City Planning Department

Memo

To: Cranston City Plan Commission
From: Doug McLean, AICP, Principal Planner
Date: September 30, 2021
Re: Dimensional Variance Application for 250 Warwick Avenue – Front Setback and Signs

Owner: WDP Warwick, LLP
Applicant: First Hartford Realty
Location: 250 Warwick Avenue, AP 2, Lots 1049-1052, 1054-1055, 1096-1103, 1105-1113, and 3984
Zone: C-5 (Heavy business, industry)
FLU: Highway Commercial/Services

SITE PLAN

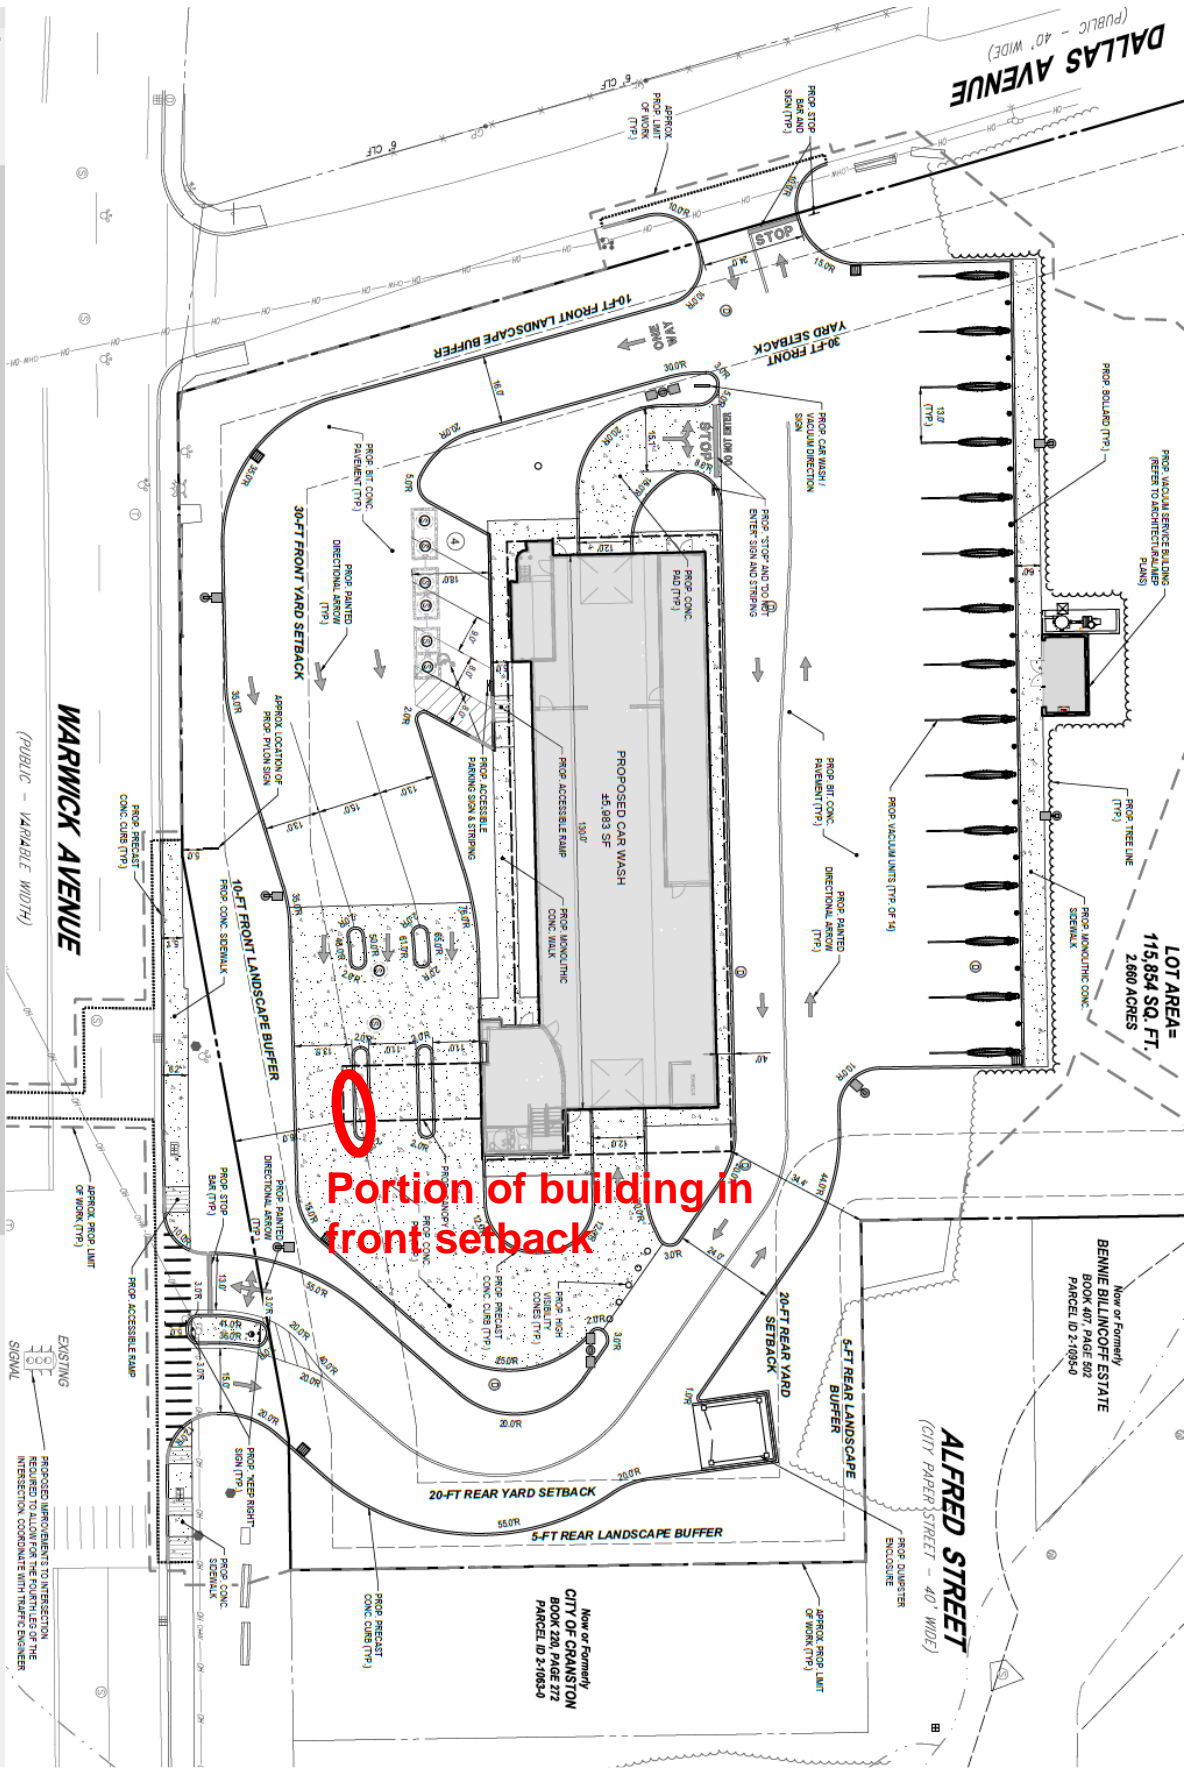
Portion of building in
front setback

- There is a proposed awning over the drive-up order points that extends 4 feet into the front setback. This portion of the structure will be 26 feet from the front property line whereas 30 feet is required.

- Staff finds that the proposed front setback relief will not detract from the streetscape aesthetics along Warwick Avenue and, in fact, this is the Planning staff's preferred layout of this type of use as compared to siting the vacuum facilities along a public right-of-way.

- Staff finds that the quantifiable percentage of relief requested is minimal. The applicant seeks 4 feet of relief compared to a 30 foot front setback requirement, which equates to being short by approximately 13% of the required standard.

- Staff finds that only a small portion of the building will be located within the front setback as illustrated on page 7 of this memo.
- The Comprehensive Plan Land Use Element; Principle 4 reads: *"Protect and stabilize existing residential neighborhoods by basing land use decisions on neighborhood needs and quality of life. Protect the natural, historic and visual resources that define the neighborhoods"* (p. 34). Staff finds that relief in this case would not detract from the visual resources that define the area and therefore the application is generally consistent with the Comprehensive Plan.

SIGN 2 - SMALL CHANNEL LETTERS

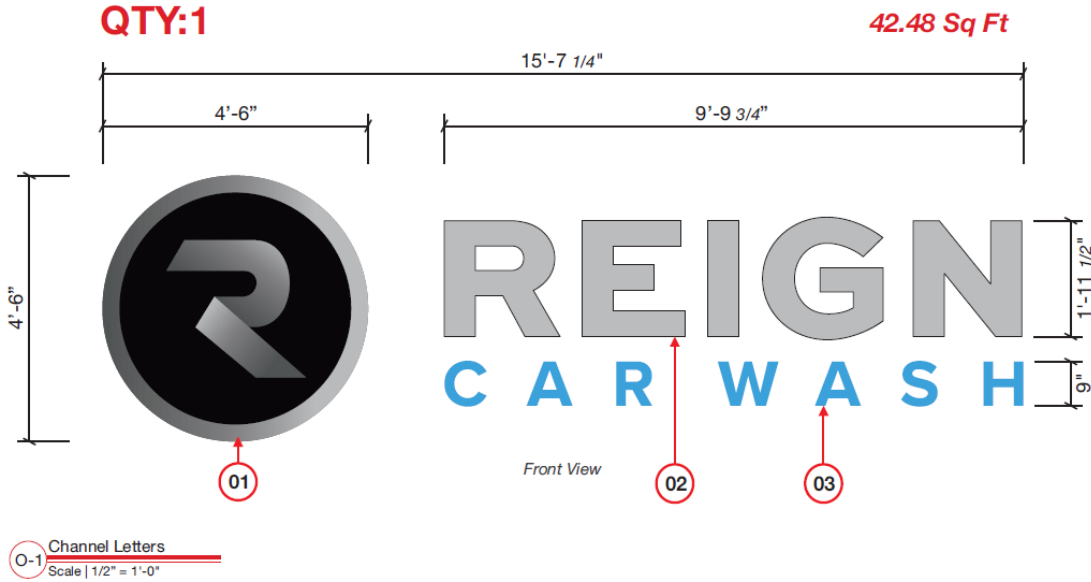
SIGN FACING SOUTH TOWARD UNDEVELOPED LOT:

- The applicant proposes two (2) new wall signs that are approximately 71 sqft. and 87 sqft respectively. The maximum allowed area for a wall sign in the C-5 zone is 30 sqft so both wall signs require relief.

- Staff finds that the proposed wall signs are suitable because they are proportionate to the larger scale of the proposed structure (see graphics on page 8 of this memo).

SIGN 3 - LARGE CHANNEL LETTERS

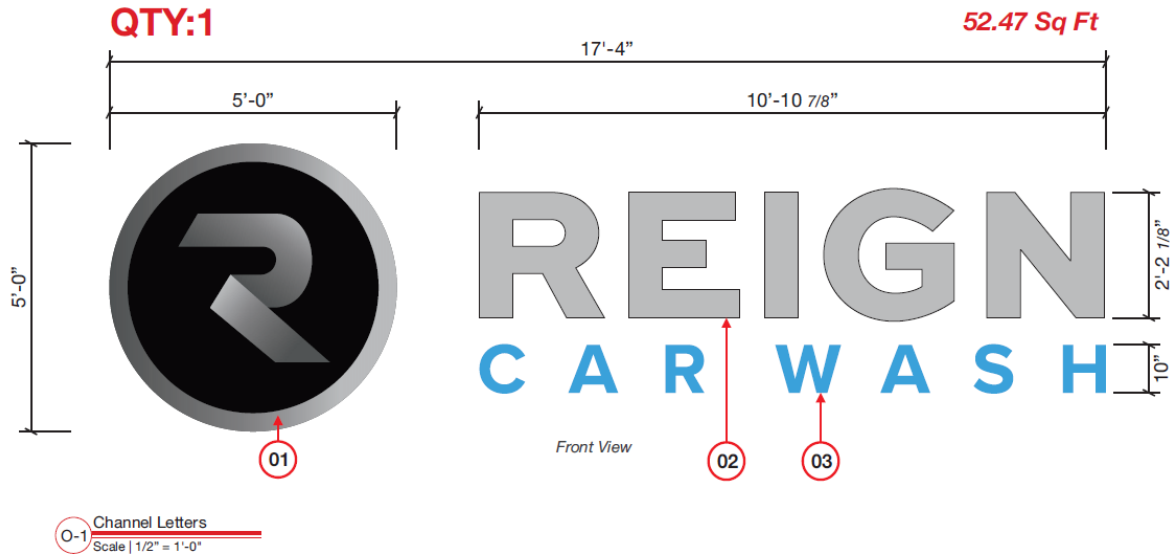
SIGN FACING WEST TOWARD WARWICK AVE.:
